MEETING AGENDA  
SAN ONOFRE UNITS 2 & 3 PRESSURIZER SAFETY  
VALVE INLET PIPING MODIFICATIONS 9 - 16 - 81

SAFETY VALVE SYSTEM MODIFICATION

### EFFECT OF CHATTER

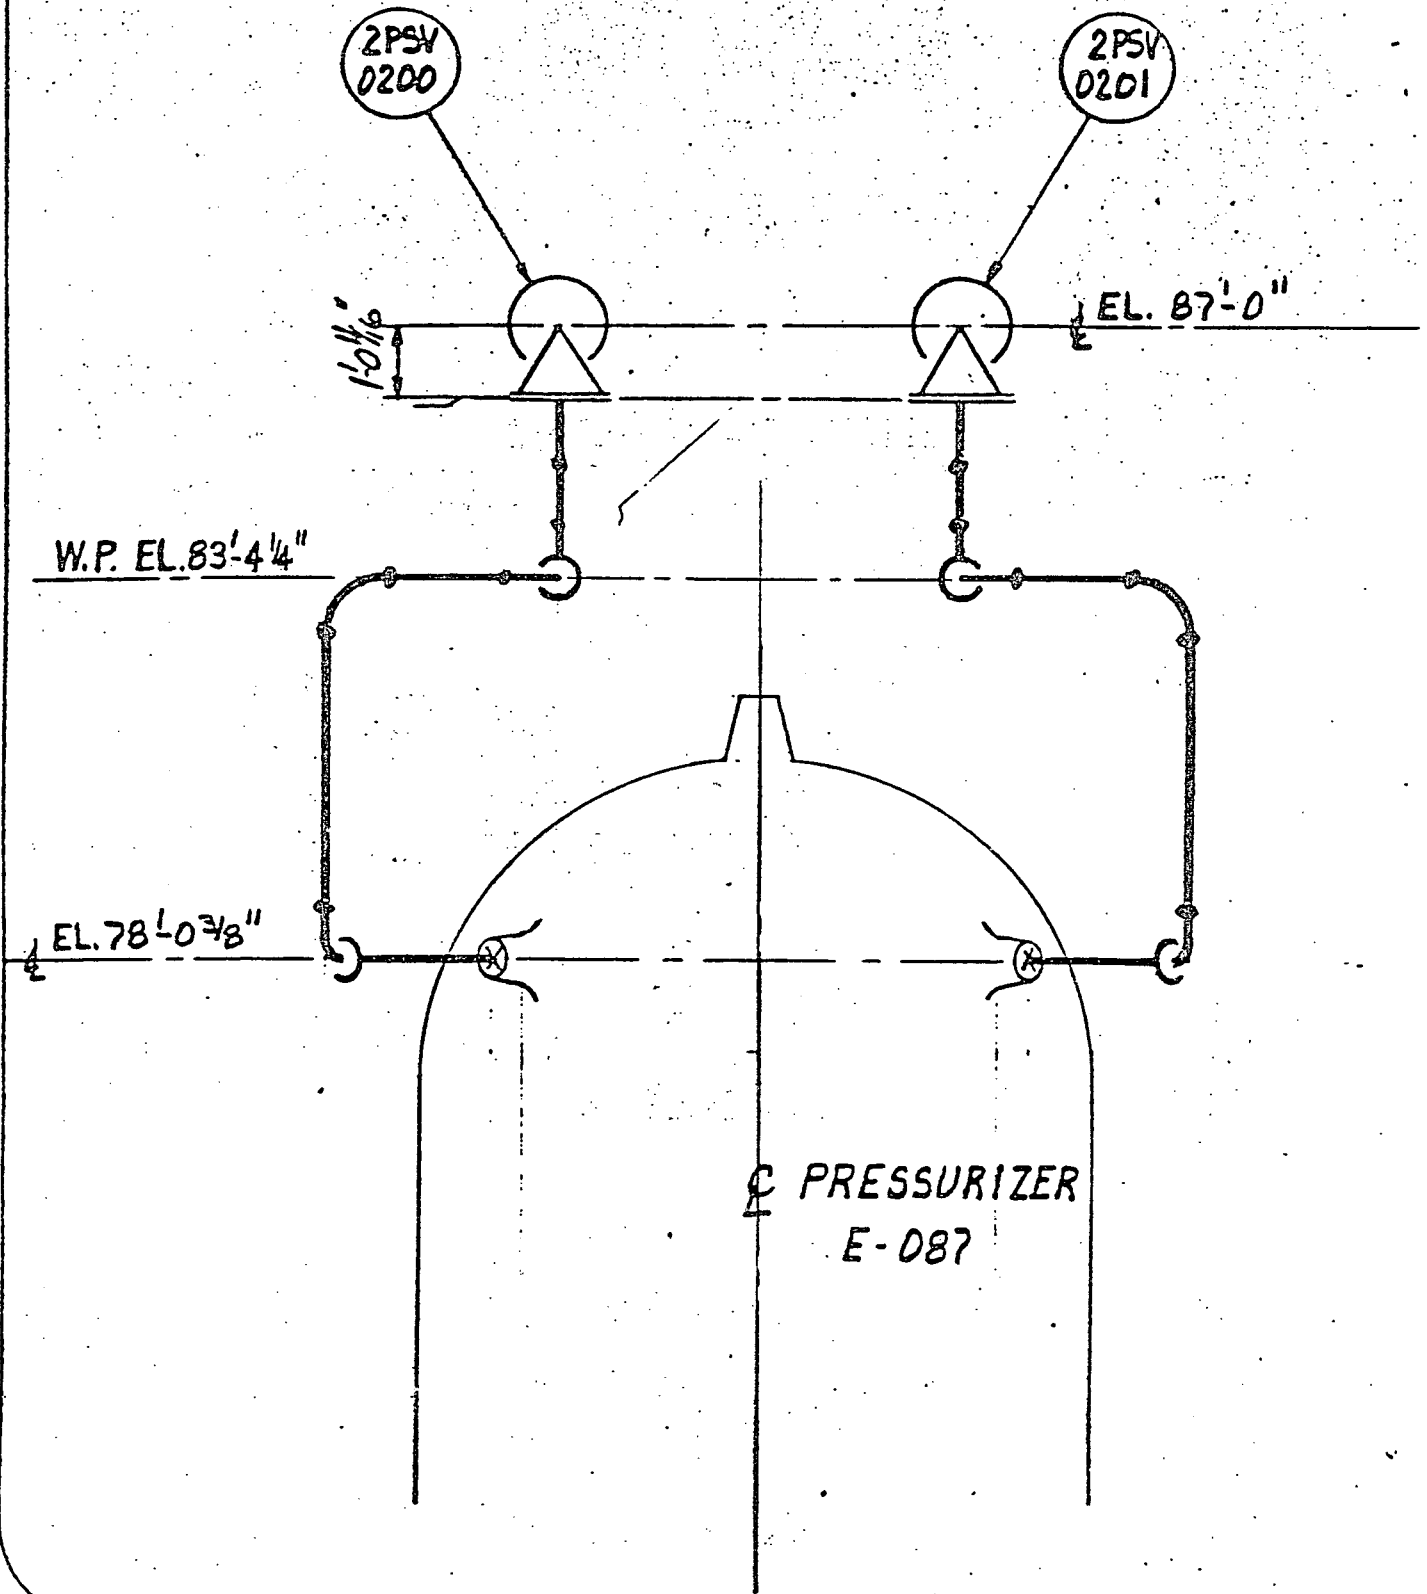
- . NON-COMPLIANCE WITH ASME CODE
- . POTENTIAL FOR VALVE DAMAGE
- . POTENTIAL FOR DECREASED RELIEVING CAPACITY

EPRI TEST ON 6/2/81 RESULTED IN VERY LONG CHATTER (TWO MINUTES). VALVE CLOSED WITH MINIMAL LEAKAGE (<1GPM).

# EXISTING ARRANGEMENT

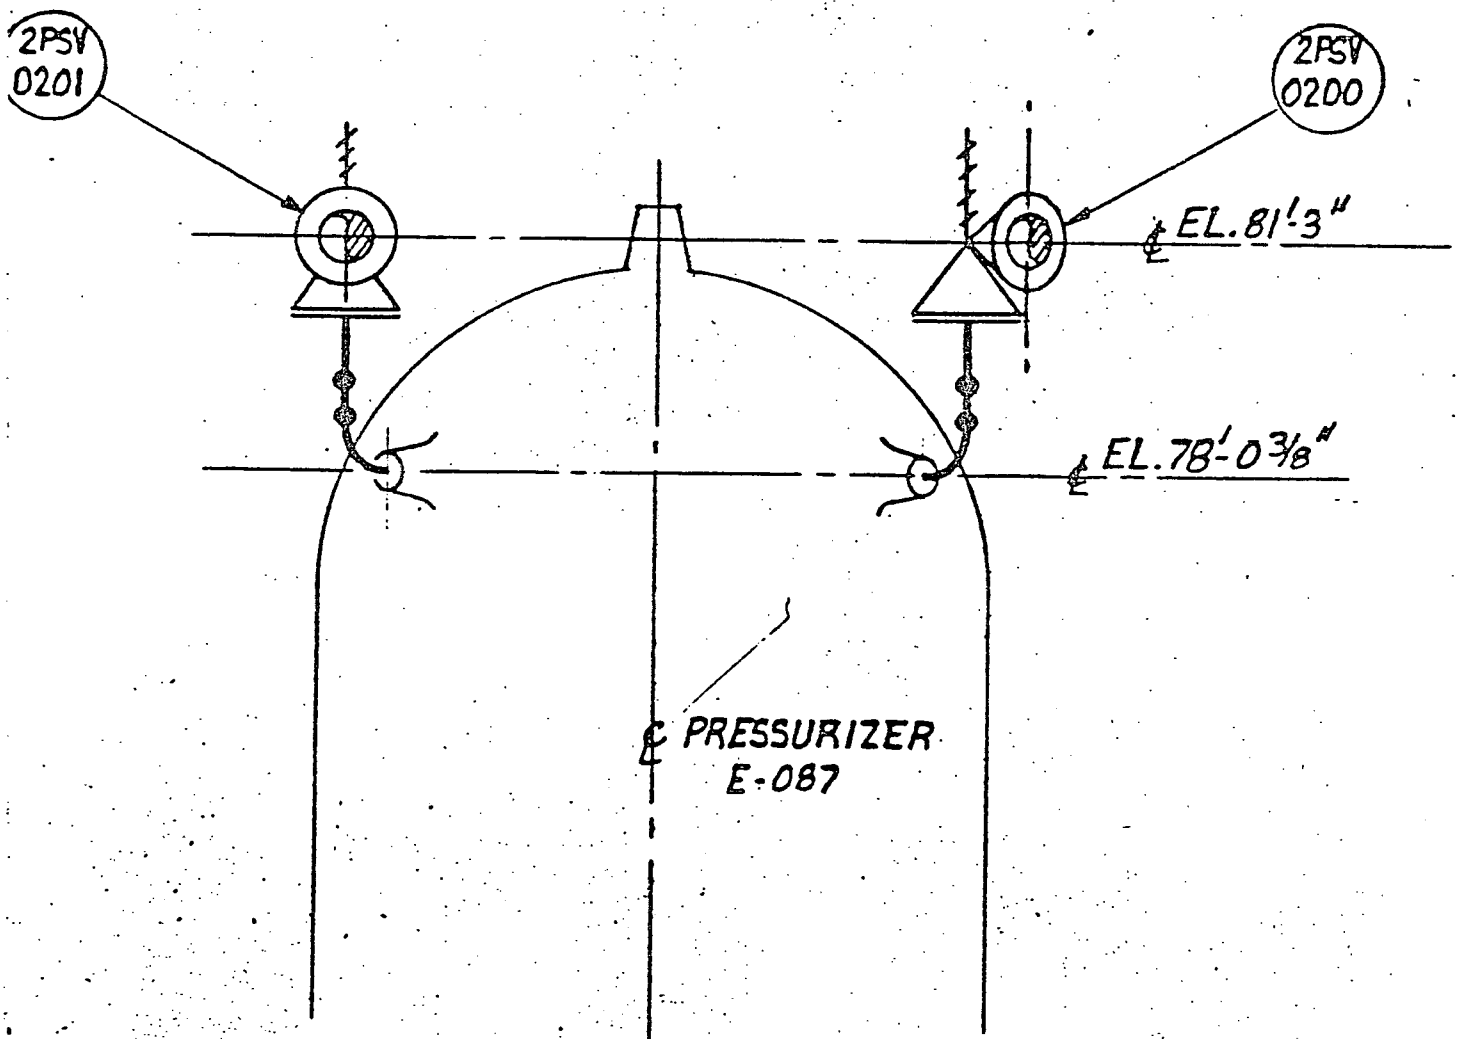
SHORTEN INLET PIPE

ADJUST VALVE RING SETTINGS

SHORTEN INLET PIPING

INCREASE BLOWDOWN SETTING
